HOWELL TOWNSHIP PLANNING COMMISSION REGULAR MEETING

3525 Byron Road Howell, MI 48855 May 27, 2025 6:30 pm

AGAPE CITY CHURCH

SCREEN FENCE DETAIL

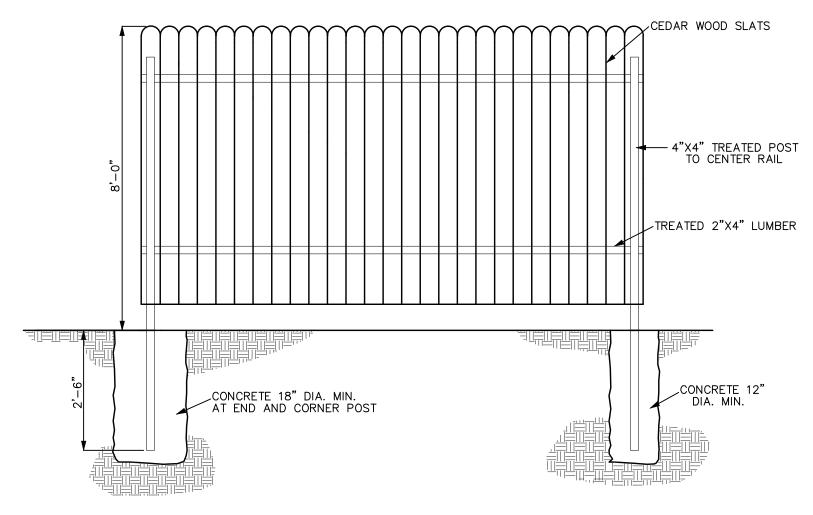
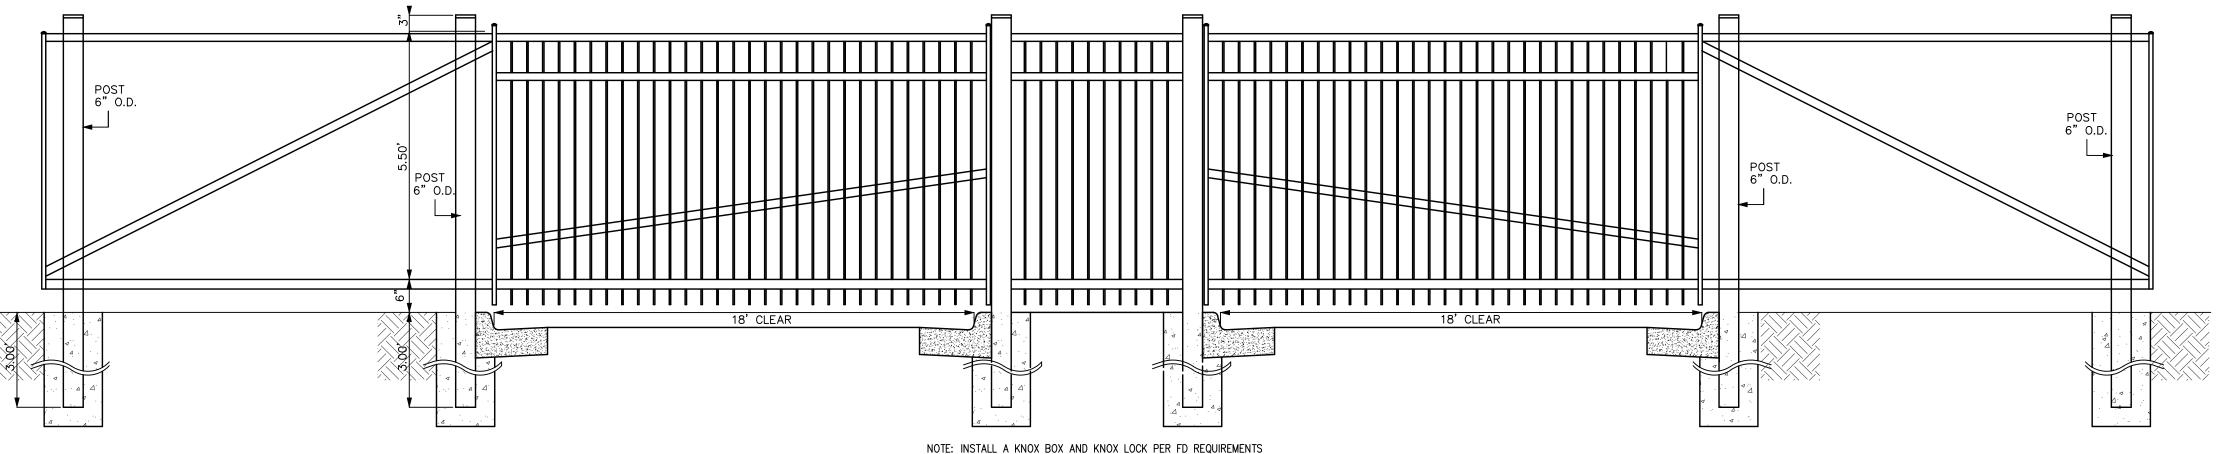
Fencing details are provided on Sheet DT1 of the submitted plans.

DOUBLE DUMPSTER ENCLOSURE DETAIL

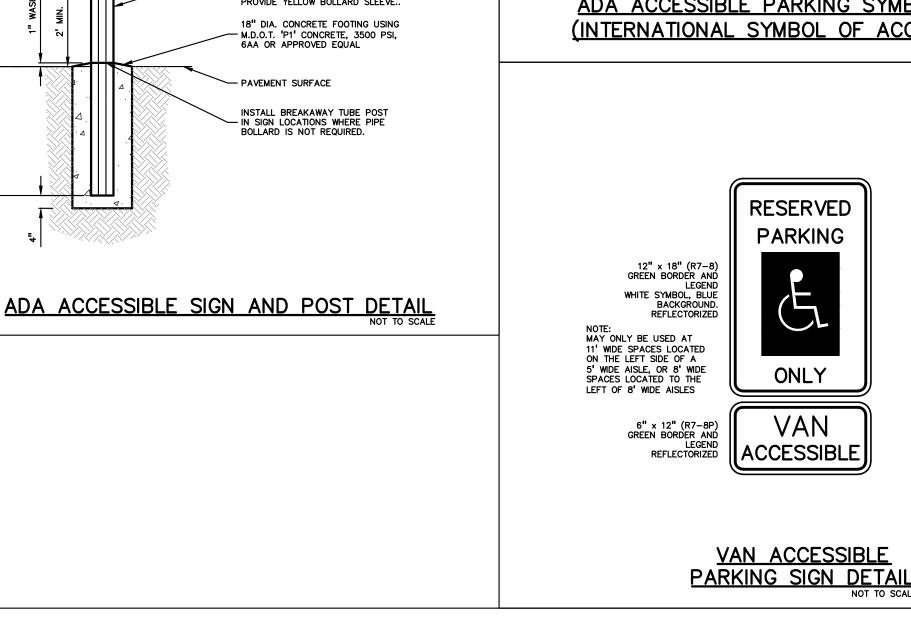
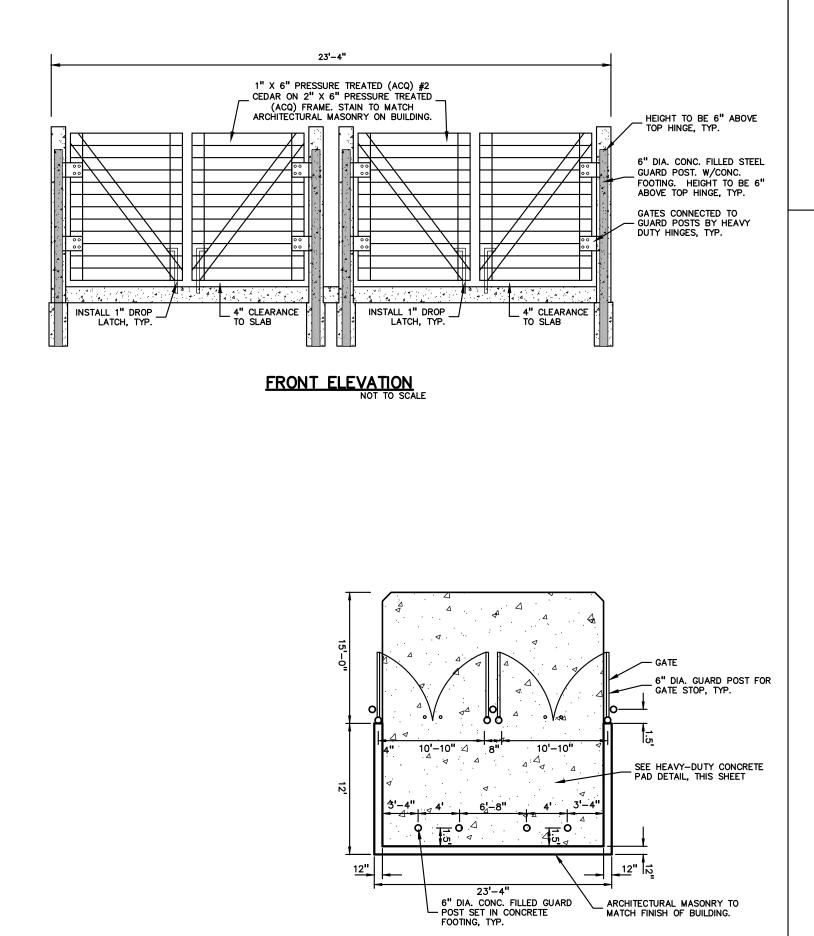
Two (2) trash enclosures have been proposed northwest of the building. The applicant has provided details on Sheet C-9.0. The proposed height is six (6') feet with masonry to match the principal building. The enclosure gates are planned to be cedar with stain to match the principal building architecture.
